## **Proposal for 03 series of amendments to UN Regulation No. 67 (LPG vehicles)**

The text was prepared by the expert from Turkey. It proposes amendment to UN Regulation No. 67 on LPG vehicles to **insert new provisions on the location on the vehicle of the filling unit.**

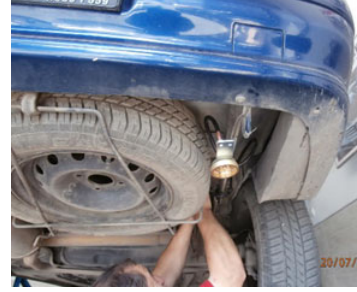
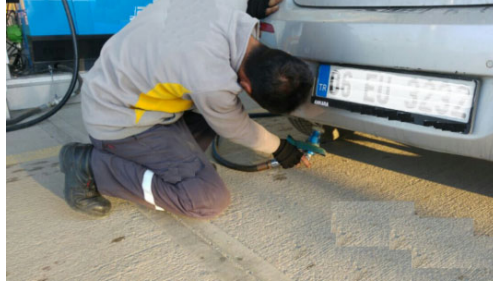
- 1.** In the current text of UN Regulation No. 67, there are no provisions on the location of the filling unit of the LPG container outside the vehicle. The filling unit located under the vehicle causes problems including:
  - (a) Difficulties with filling the LPG container;
  - (b) Risks involved on occupational health and safety of LPG container filling operators;
  - (c) When filling the container, obliges operators to kneel down/lie down on the ground;
  - (d) When the vehicle is in laden position, the filler pistol maybe unable to fit the space between ground and filling unit and prevents the filling of the container.

**"6.15.10.8. The filling unit shall not be located under the floor or the chassis of the vehicle. The centre of outlet of filling unit shall be above 350 mm from the ground surface when the vehicle is in its reference mass. In the case the outlet of filling unit is located between 350 mm to 1,200 mm above the ground and directed downwards, in vertical plane the angle between horizontal road surface and outlet plane of the filling unit shall be equal to or greater than 60 degrees."**
